FINAL DRAINAGE LETTER FOR LOT 6 OF CLAREMONT BUSINESS PARK 2 FILING NO. 1

EL PASO COUNTY, COLORADO

MARCH 2021

Project #44-037
PCD – SP 20-000

PROPOSED DRAINAGE MAP - LOT 6

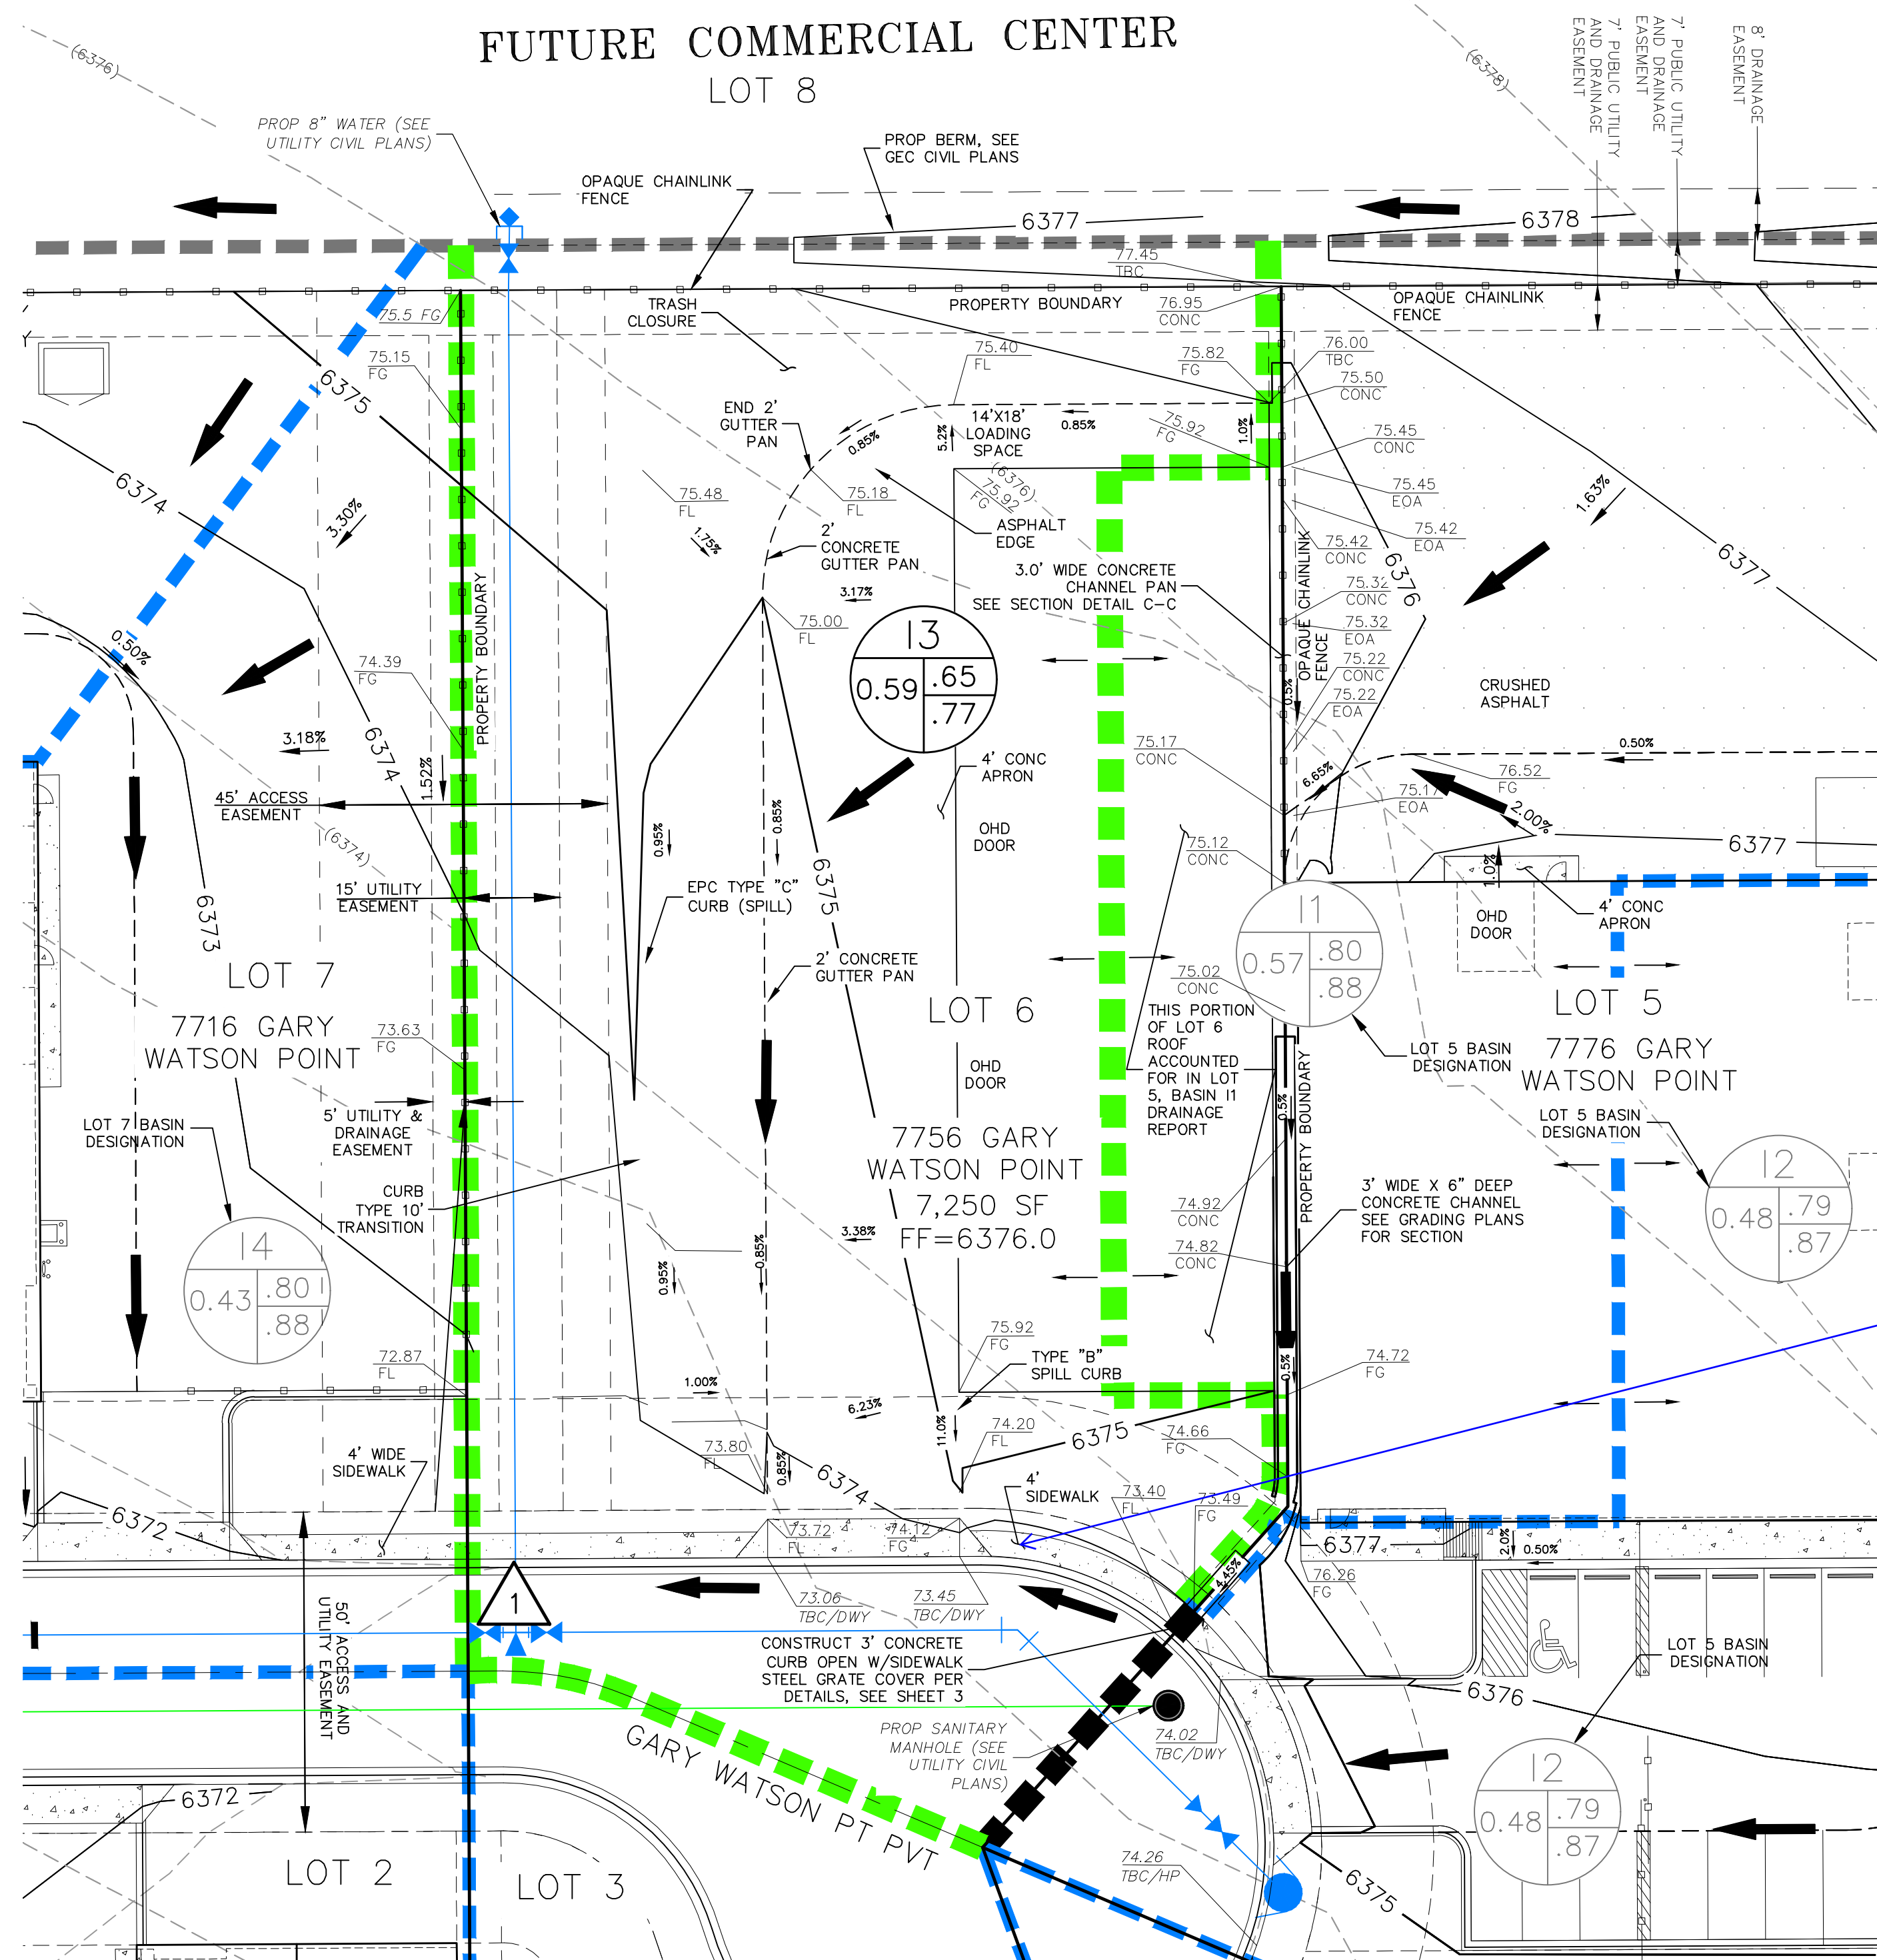
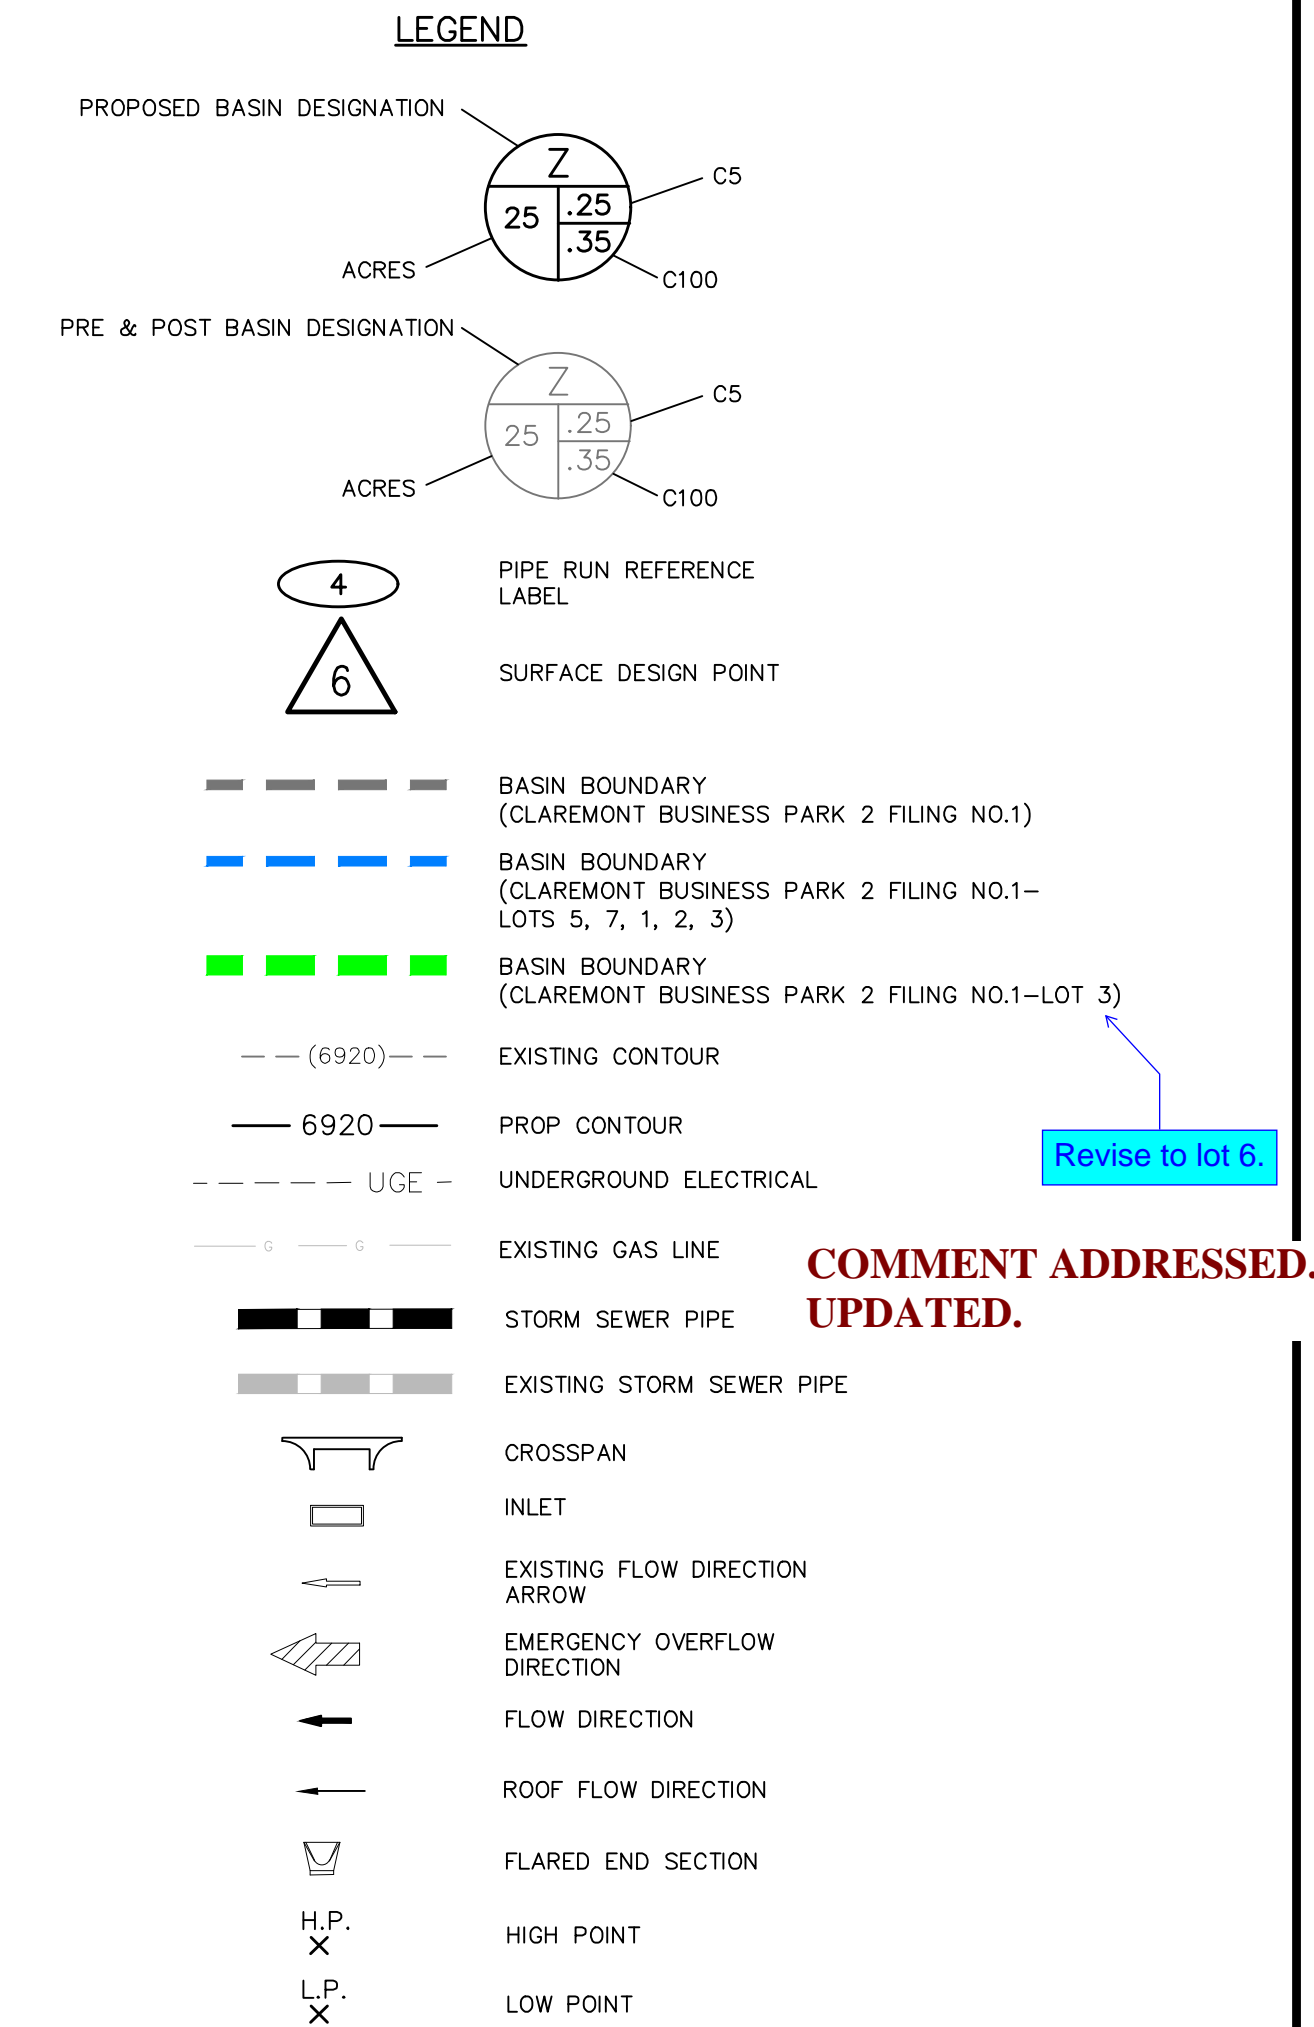
Revise to lot 6.
COMMENT ADDRESSED.
UPDATED.

Revise the sidewalk to match the GEC and Site plan

COMMENT ADDRESSED.
UPDATED.
